## Technical Memorandum

**TO:** Ralph Dollhopf, United States Environmental Protection Agency

**FROM:** Sonny Rutkowski, Rex Johnson, Chris Lantinga Weston Solutions, Inc. (WESTON) START

**SUBJECT:** Enbridge Oil Spill Submerged Oil Containment Strategy: Recommendations for Submerged Oil Containment at Morrow Lake Delta, Ceresco Dam, and Mill Pond Impoundments

FIGURE 1  
WINTER SUB-OIL CONTAINMENT OPTIONS  
MORROW LAKE DELTA IMPOUNDMENT  
ENBRIDGE OIL SPILL  
KALAMAZOO & CALHOUN COUNTIES, MI  
CREATED: OCTOBER 2012

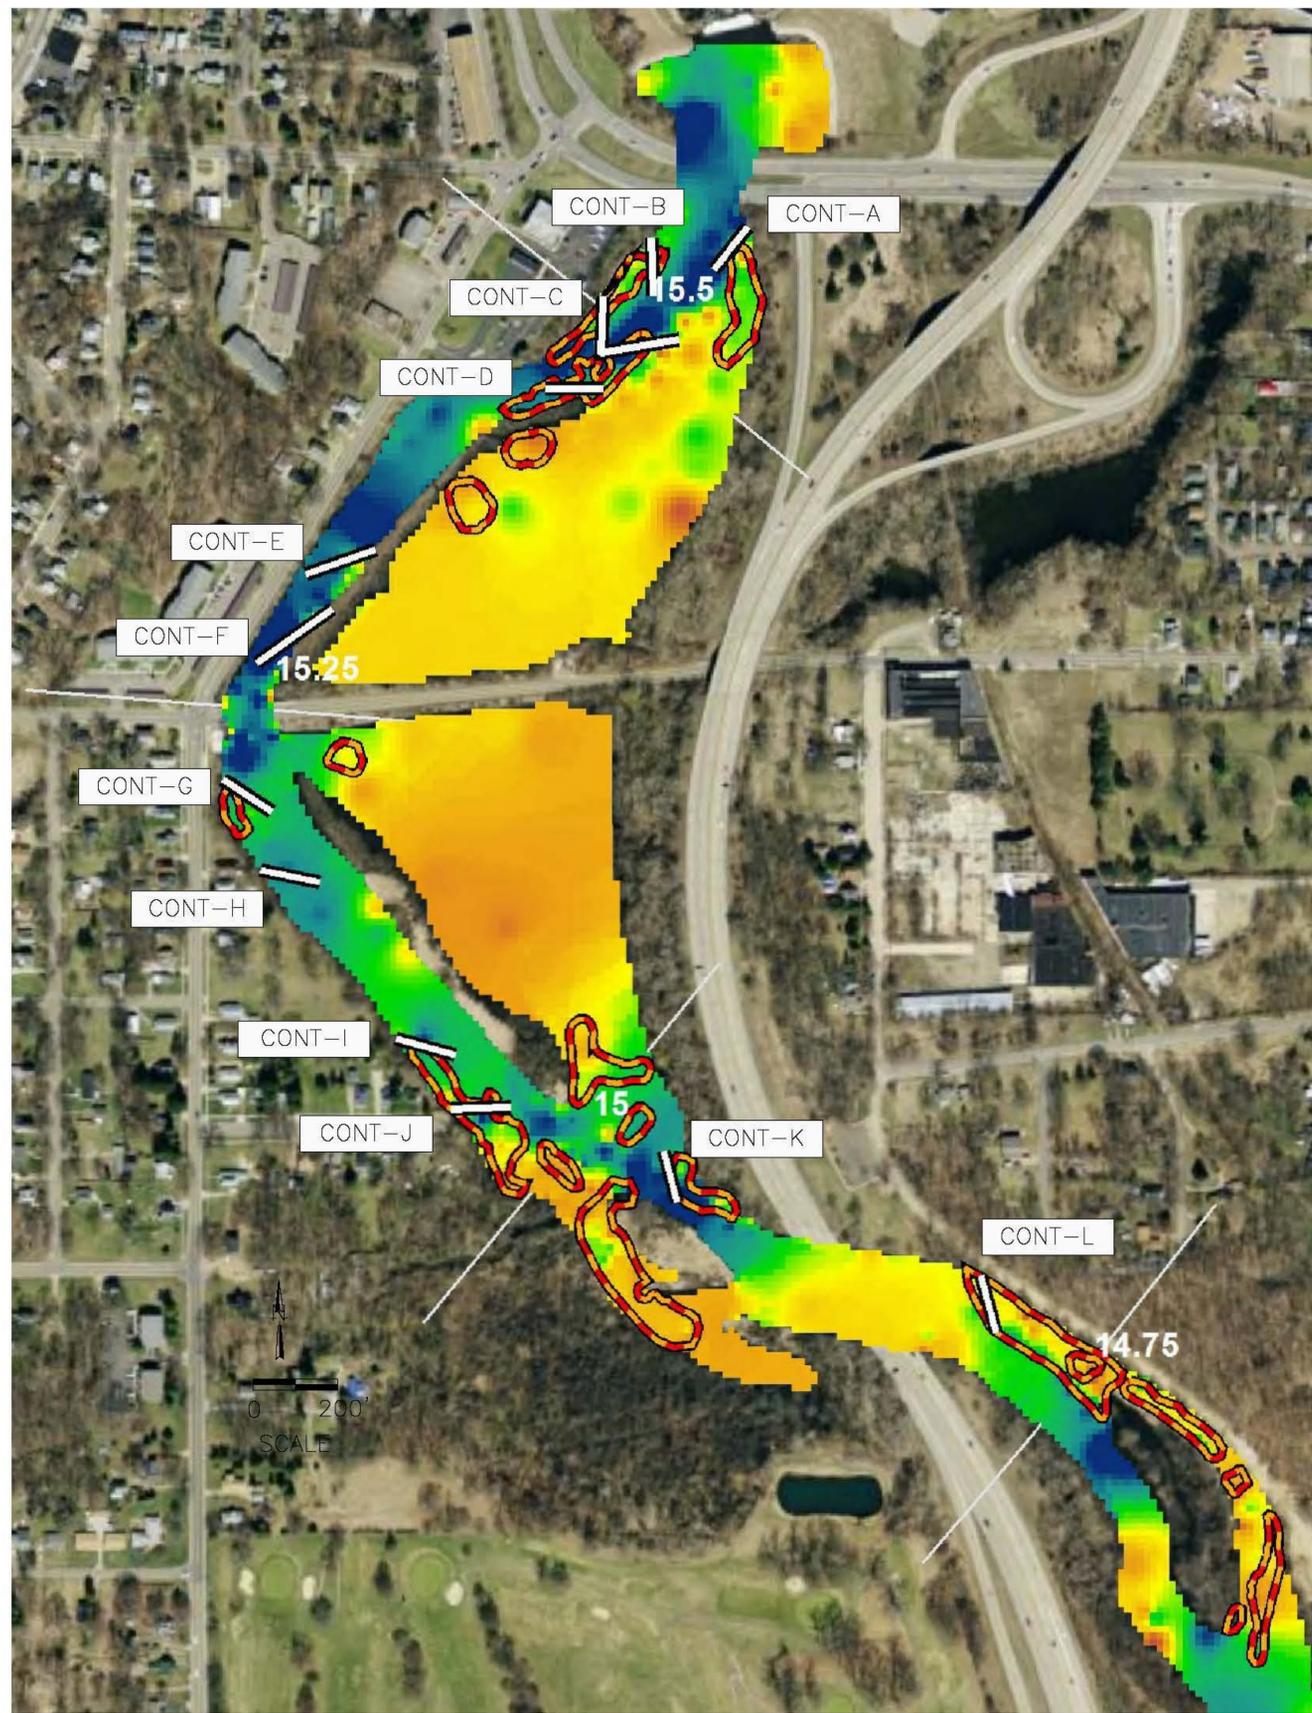
Similar to the strategy of the June 2012 installation, the strategy of the proposed winter reconfiguration at MLD allows the mid and upper water column to pass unimpeded. However, curtains and cables are lowered to minimize contact with anticipated ice floes. Chains to weight the bottom of the curtain should continue to be used to ensure the curtain bottom remains in contact with the river bottom. The full extent of forces on the anchor posts, given the recommended curtain reconfiguration and anticipated river velocities and ice floes, should be understood and documented prior to installation. A plan schematic and cross sections depicting the proposed revised curtain alignment at the MLD are shown in Figure 1.

The top cable currently suspending the existing half curtains should be lowered to a minimum of depth of 1' (or deeper) below the anticipated water/ice surface. The surface boom should be removed to limit high forces from surface ice loads. The half curtains would be supported using straps similar to the current configuration. Stronger suspension straps with less surface area should be considered to reduce potential ice fouling.

The curtains in the MLD which can be removed in accordance with the above criteria (less than 3 feet water depth along the entire length) include C1, B1 & B2, A1&A2, and D (upstream segment). The remaining containment curtain segments should remain. It is recommended that curtains should remain on sections of the remaining segments in 3 feet of design water depth or deeper since it would allow submerged oil containment up to one foot from the bottom, while retaining 1 foot plus for ice clearance.

FIGURE 2  
WINTER SUB-OIL CONTAINMENT OPTIONS  
MILL POND IMPOUNDMENT  
ENBRIDGE OIL SPILL  
KALAMAZOO & CALHOUN COUNTIES, MI  
CREATED: OCTOBER 2012

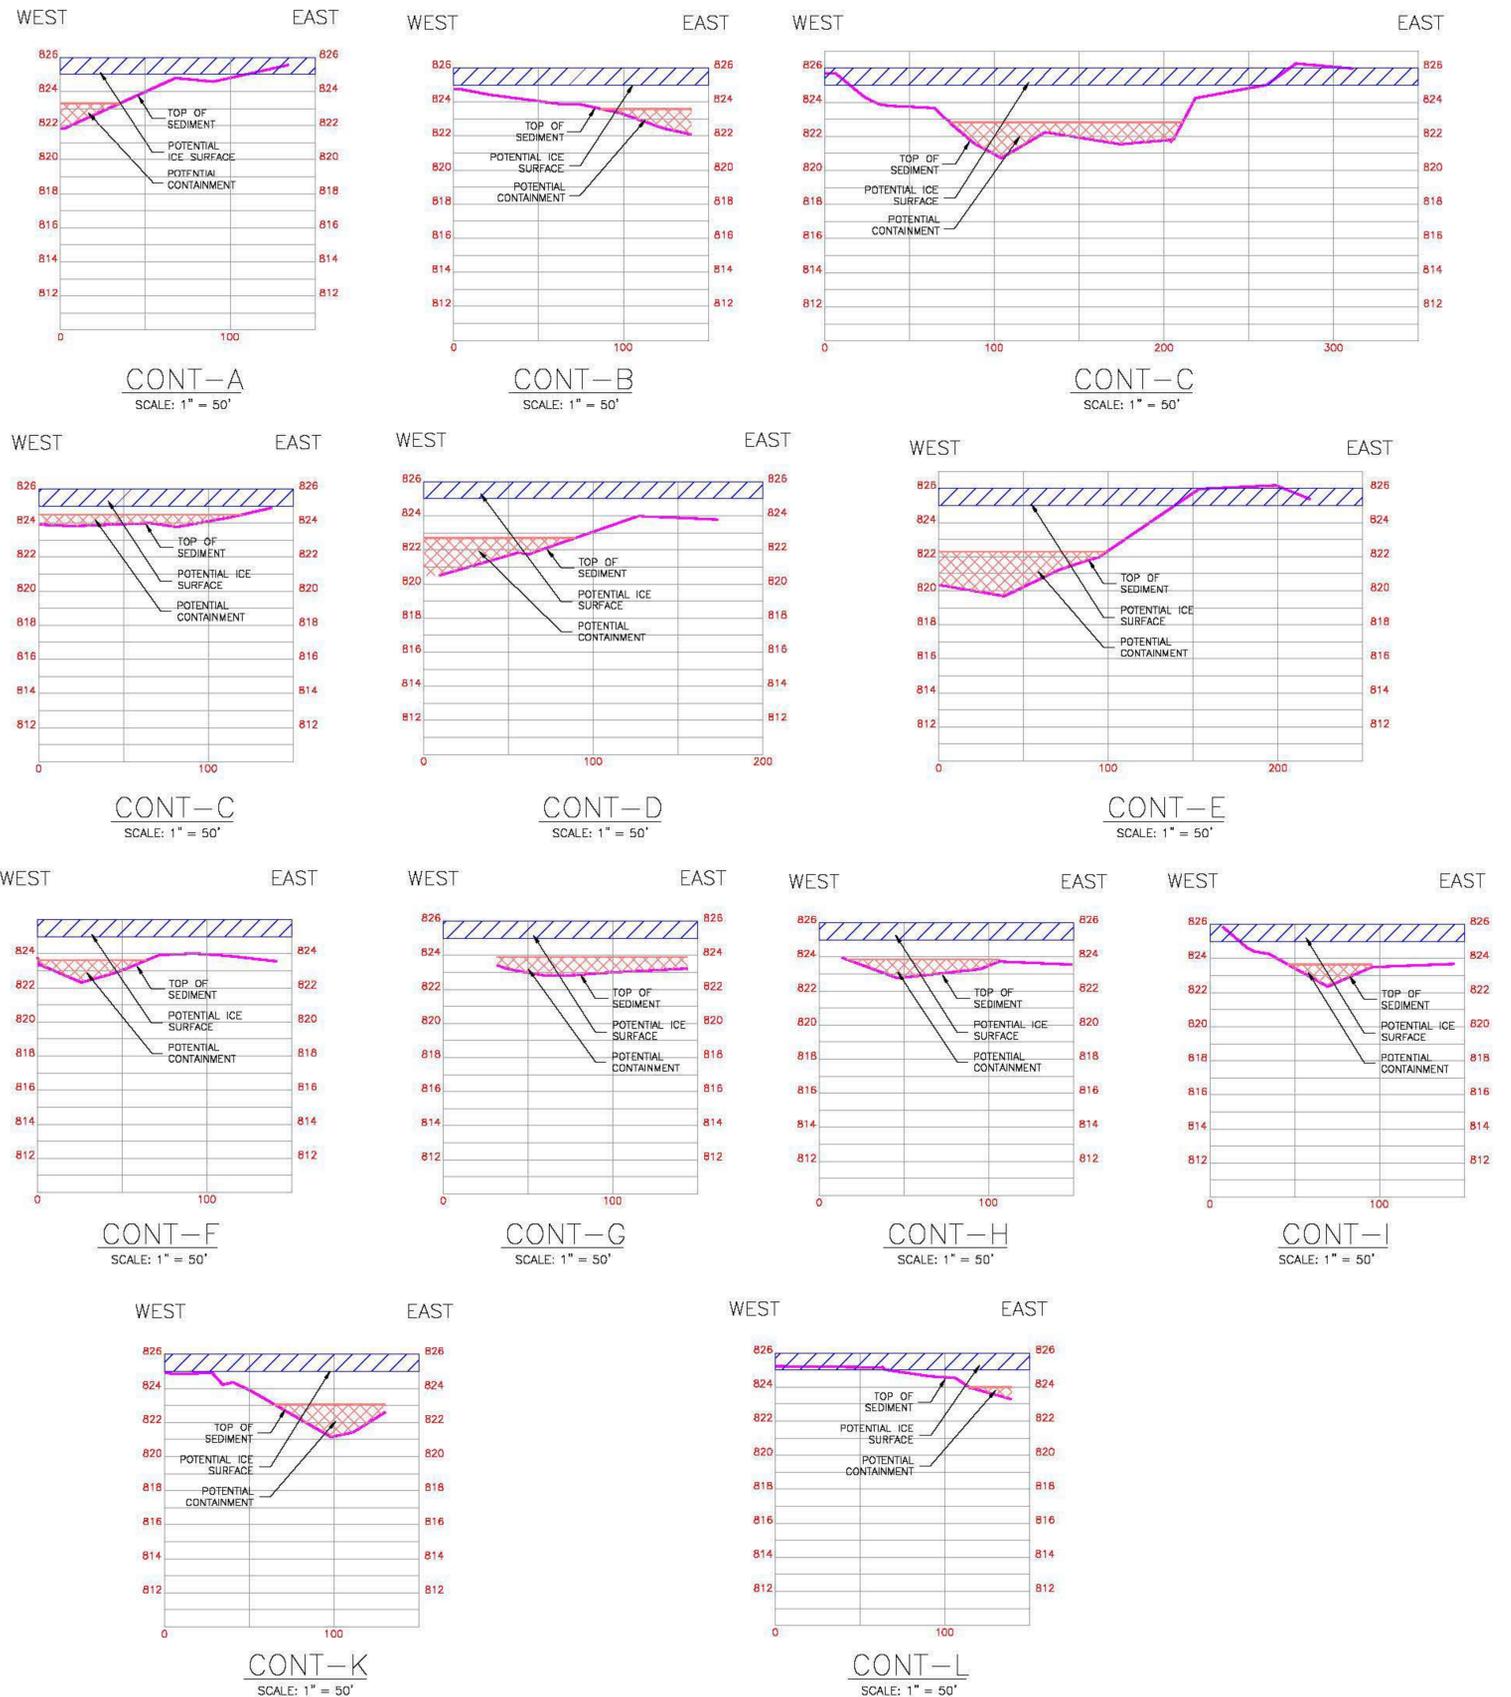
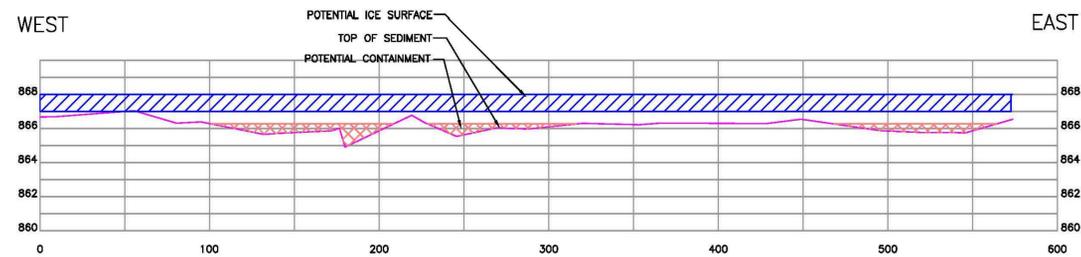
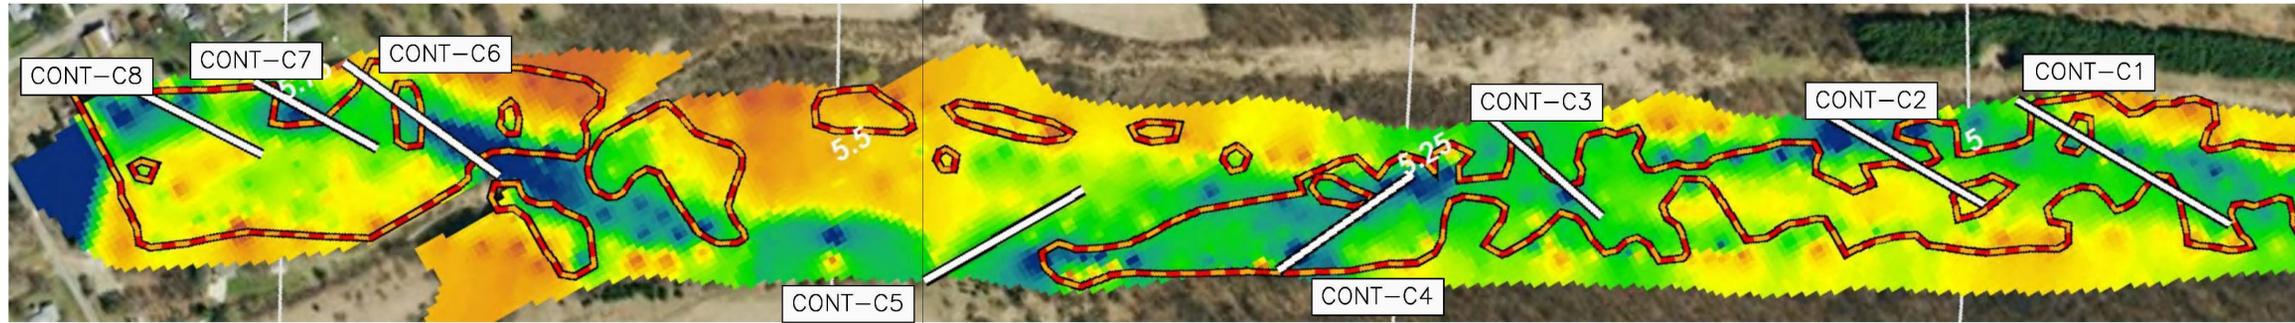
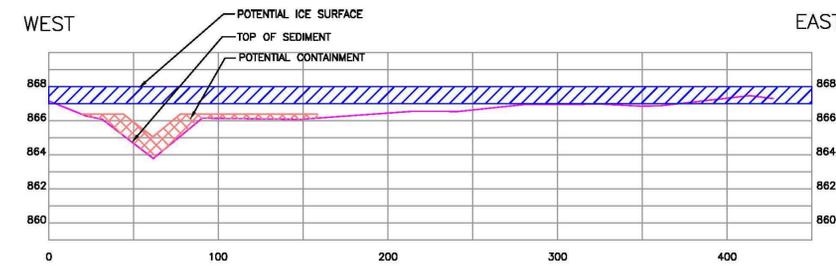
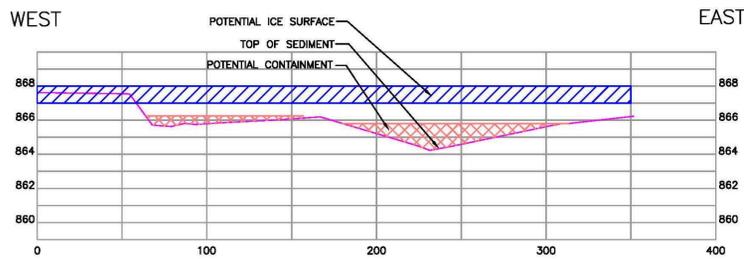
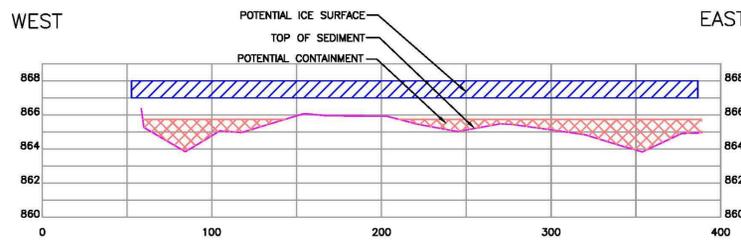
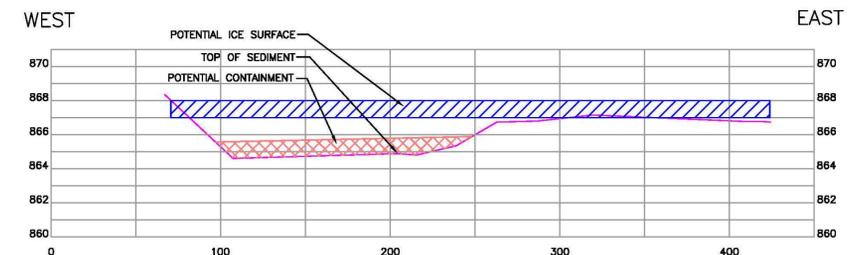
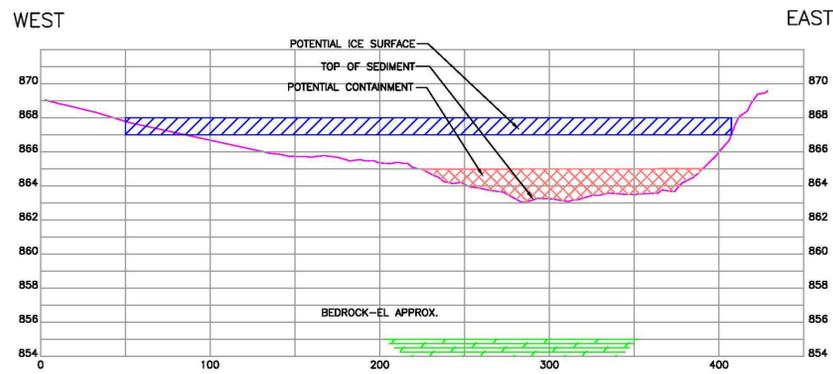
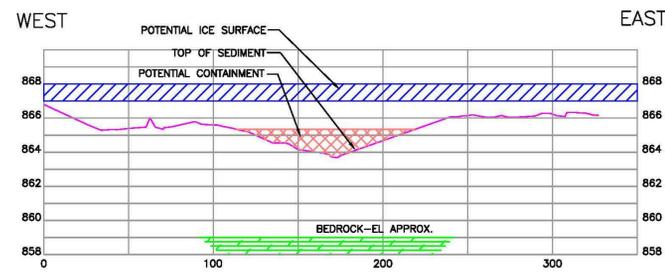
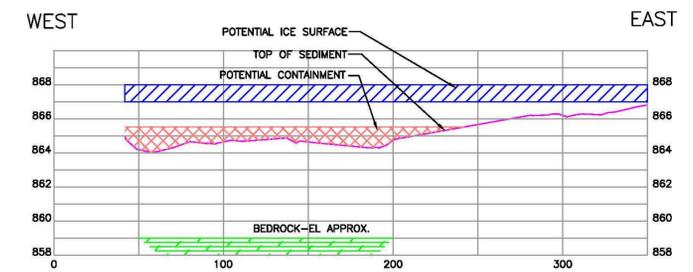
Submerged oil containment should be installed at the apparent depositional areas at the Ceresco Dam and Mill Pond impoundments using either the same submerged cable and curtain system as discussed above, or an alternate submerged containment effective at containing the submerged oil accumulation areas. See figures 9, 10, and 11 for three possible alternative concepts. If a cable and curtain system is used, it should be installed to allow 1 foot vertical ice clearance between the top of curtain and design water/ice surface, continuously in water depths of 3 feet or greater. The suggested configurations at the Ceresco Dam and Mill Pond impoundments are based on the most recent bathymetry data (Figure 2 and Figure 3). Design water elevation will be 868.0 feet at Ceresco and 826.2 feet at Mill Pond.

Figure 4  
Existing E-4 Containment System

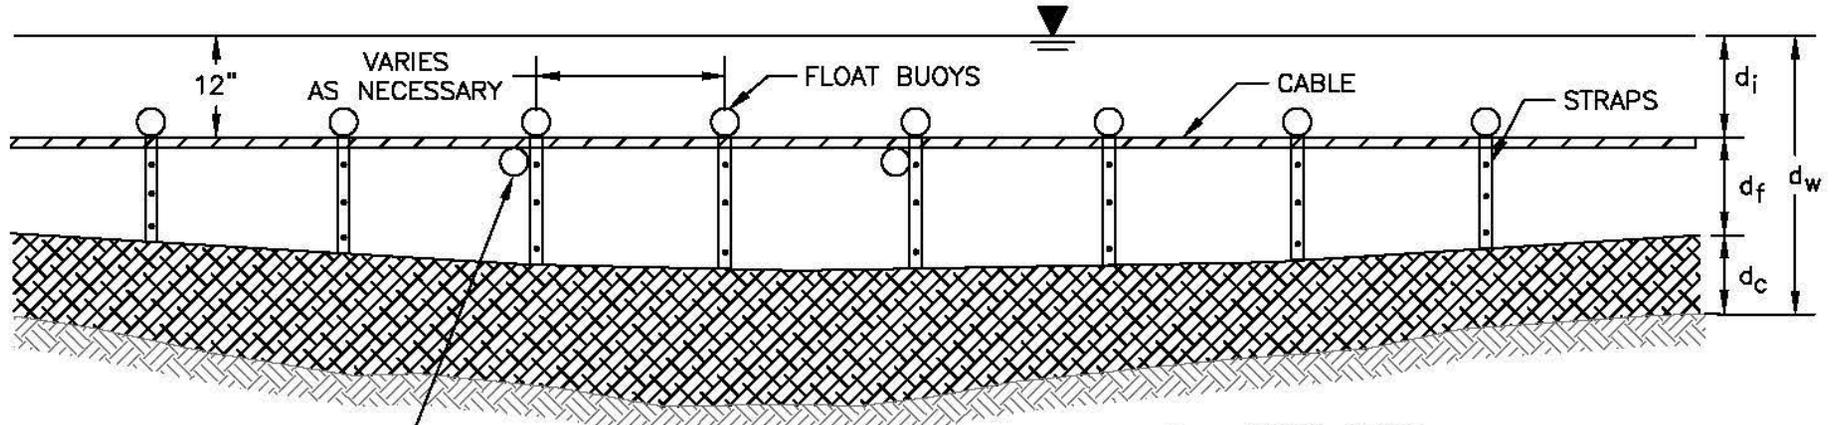
To allow adequate flow passage during freeze conditions, the straps should be adjusted so the bottom of the curtain remains in contact with the riverbed and the top of the curtain is the lesser value of 2' above the riverbed or half the elevation difference between the riverbed and the bottom of the ice zone (See Figure 5). Removal of the existing float at the top will be required prior to lowering the cable to the acceptable depth for ice clearance. In the current configuration, this float provides the necessary vertical stability force to prevent sagging and keep the cable and boom on the water surface. The new configuration must incorporate a similar cable stability component into the design. Based on rough estimates of the observed water displacement of the existing booms, the vertical force required countering the weight of the cable and boom against sagging below the surface is approximately 2-5 lbs per linear foot. Ball buoys could be affixed to the realigned cable at depth and even spacing. The size and spacing would be approximately 8-inch balls at 25-ft spacing; 10-inch balls at 50 foot spacing; or 12-inch balls at 100-ft spacing. See Figures 4 and 5.
